(AMENDED BY STAFF 2/23/89)
CITY PLANNING COMMISSION

- A. Negative Declaration
- B. Special Permit to allow the development of a racquet club on 9.5+ vacant acres that includes a 32,000 square foot clubhouse, swimming pool, 17 tennis courts and 161 parking spaces in the Creekside Oaks PUD.
- C. Amend Creekside Oaks PUD Guidelines to reduce the required 25' landscape buffer to ten feet.
- D. Amend Creekside Oaks Schematic Plan to encroach into the adopted 40 ft. recreational easement.

PROPOSAL: The applicant is requesting the necessary entitlements to develop a 9.5+ acre Racquet Club in the Creekside Oaks PUD.

APPLC. NO. P88-476 MEETING DATE February 23, 1989 ITEM NO. 17

SHEET TITLE
SITE PLAN

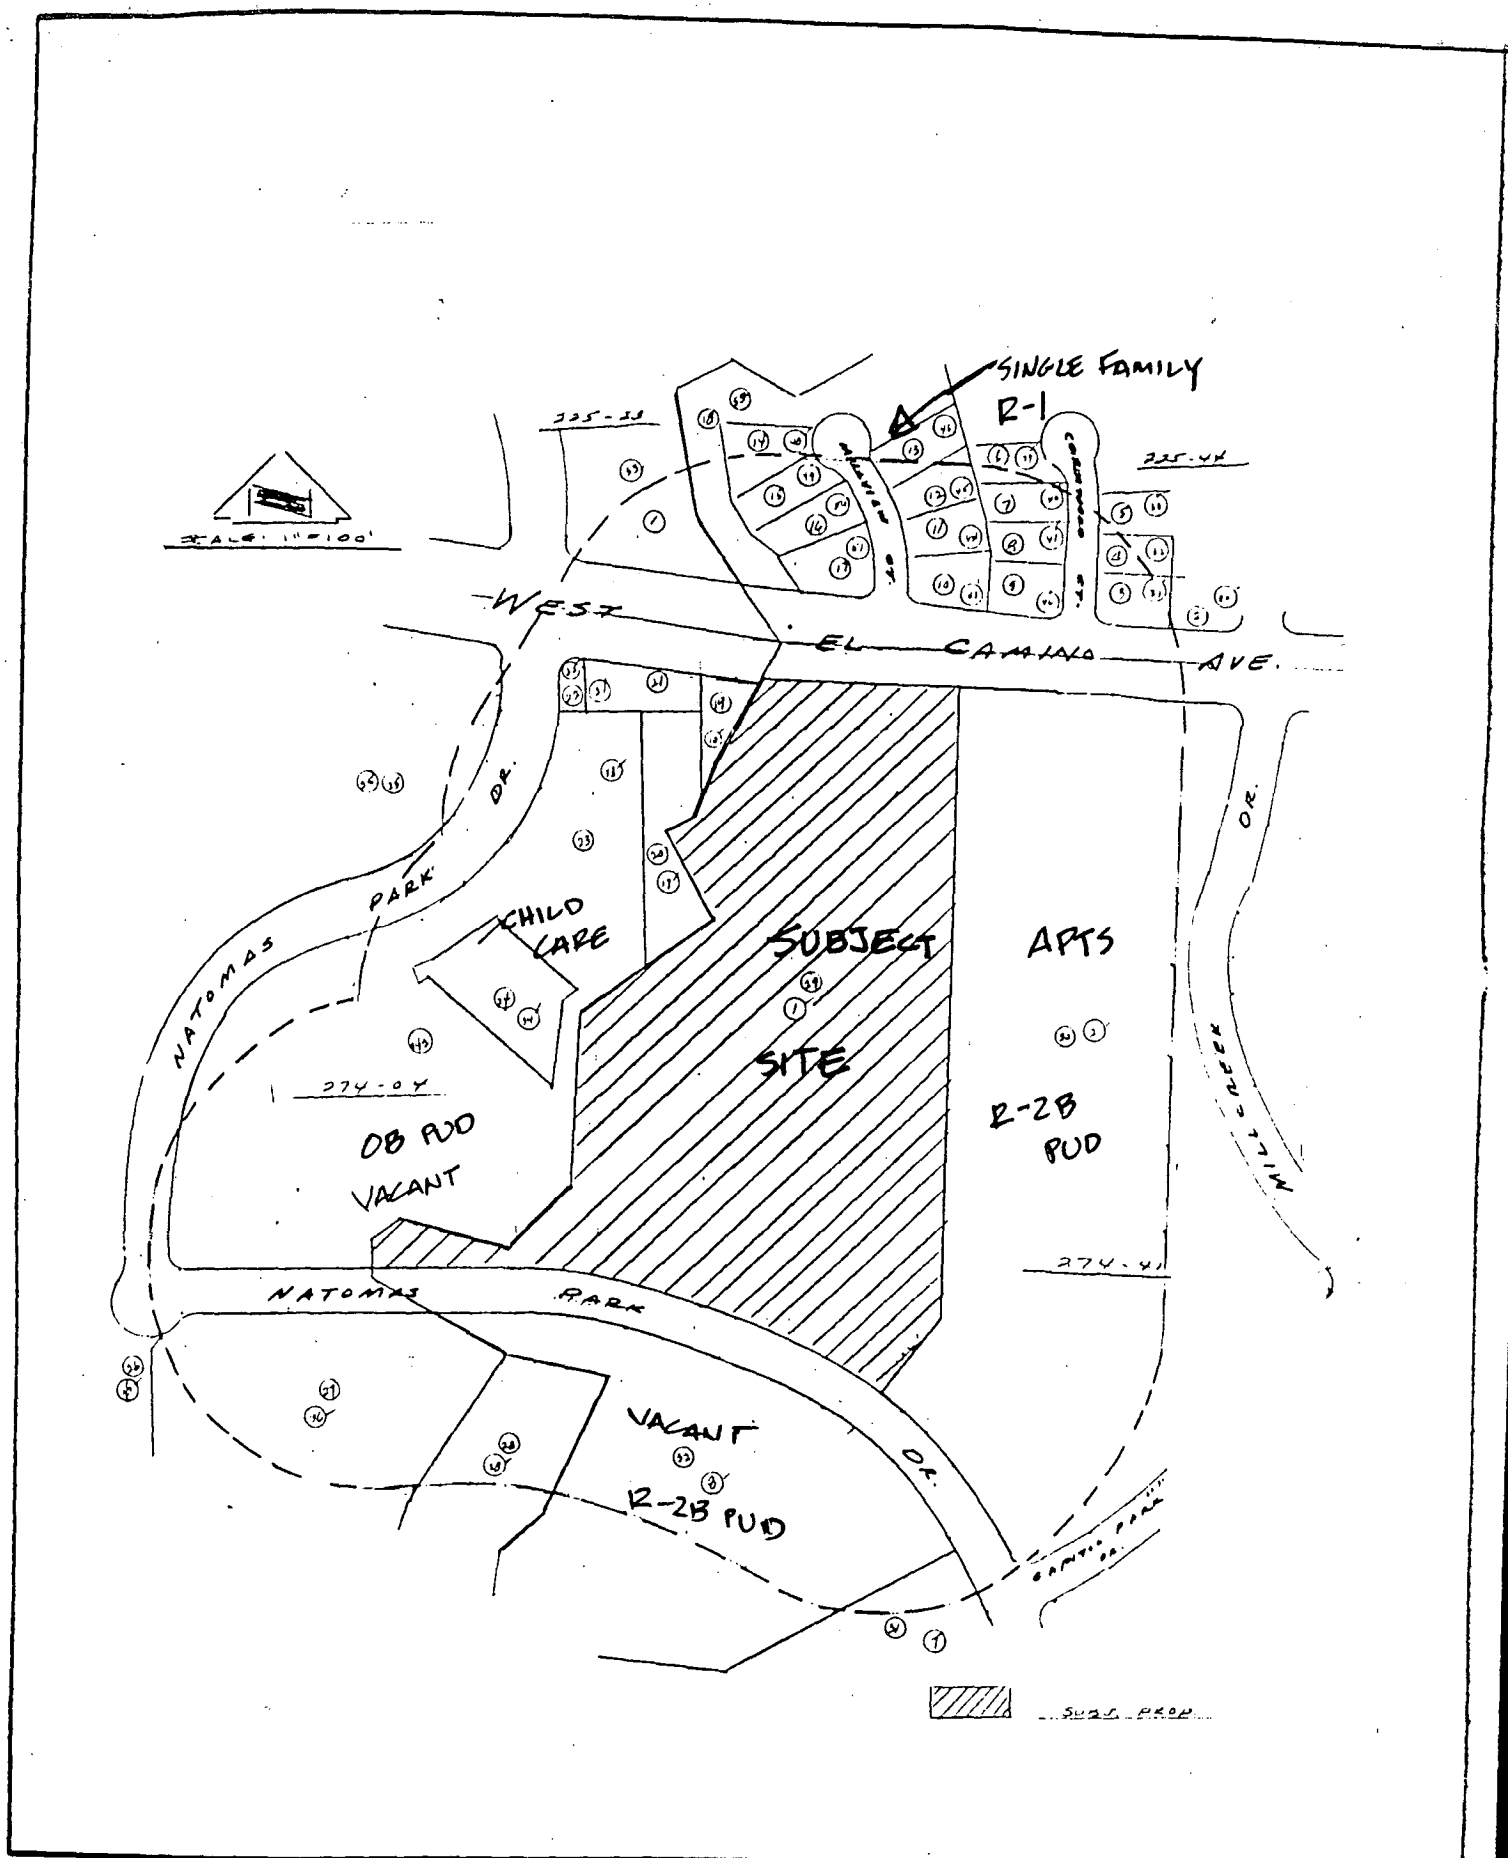
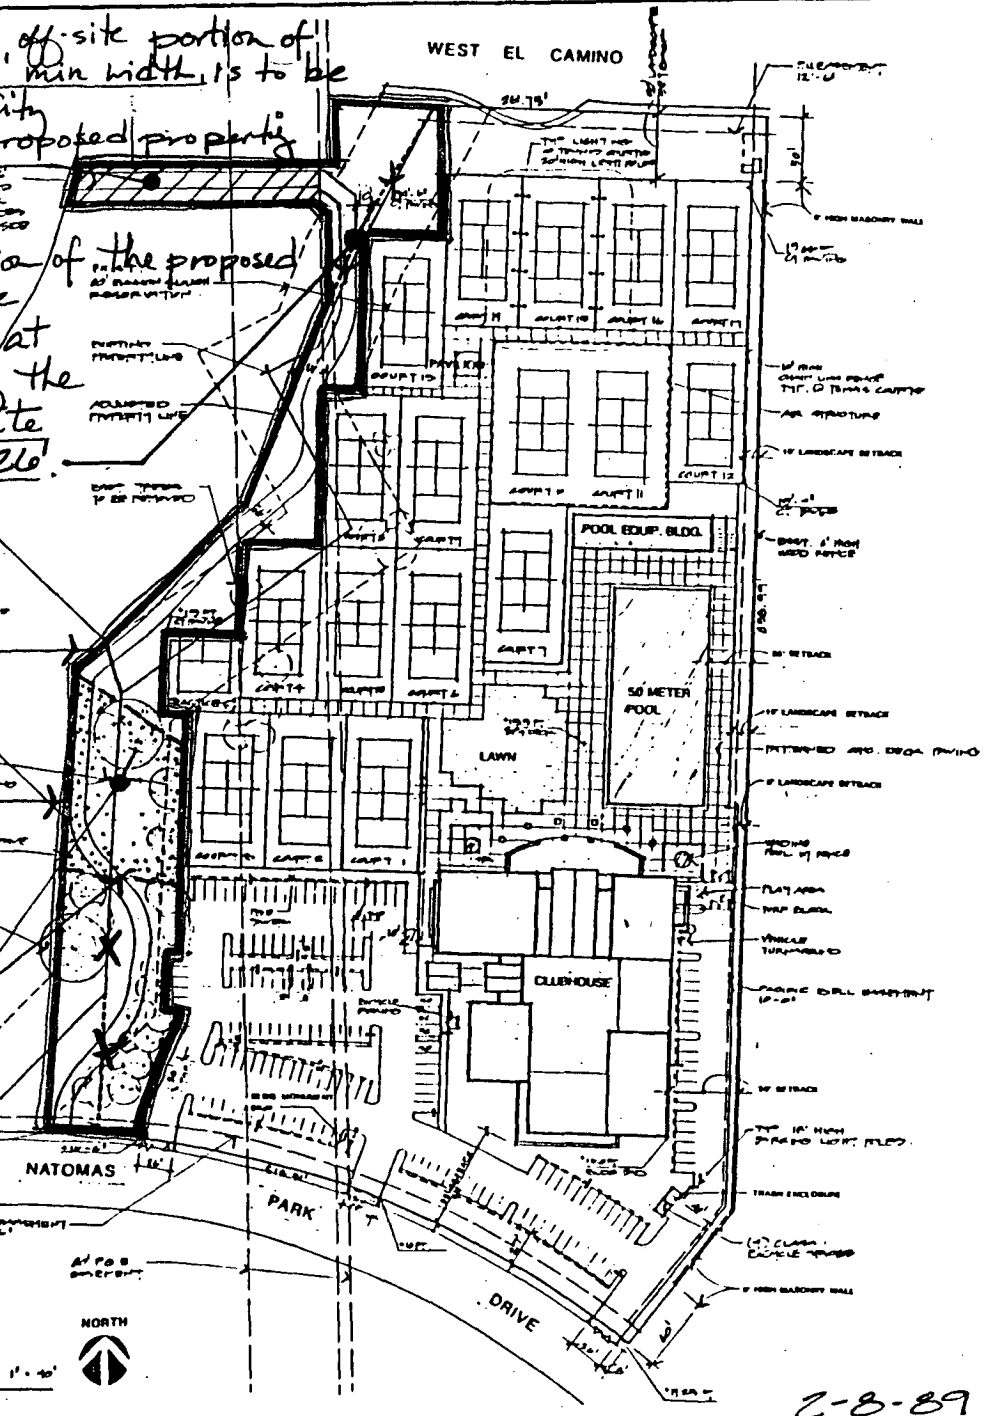
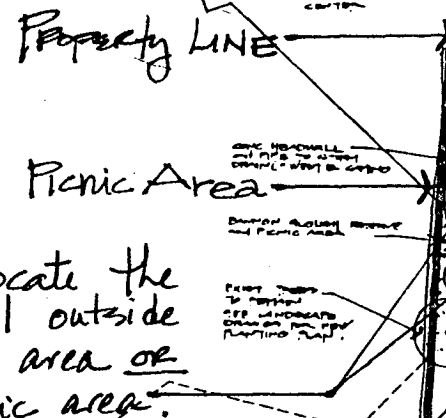
① Note that this off-site portion of the bike trail, 26' min width, is to be dedicated to the City. Show the proposed property line.

② Clarify the location of the proposed property line for Pannan Slough at the north end of the site. Minimum site width shall be 26' (not 16').

③ Either relocate the conc. headwall outside of the picnic area or move the picnic area.
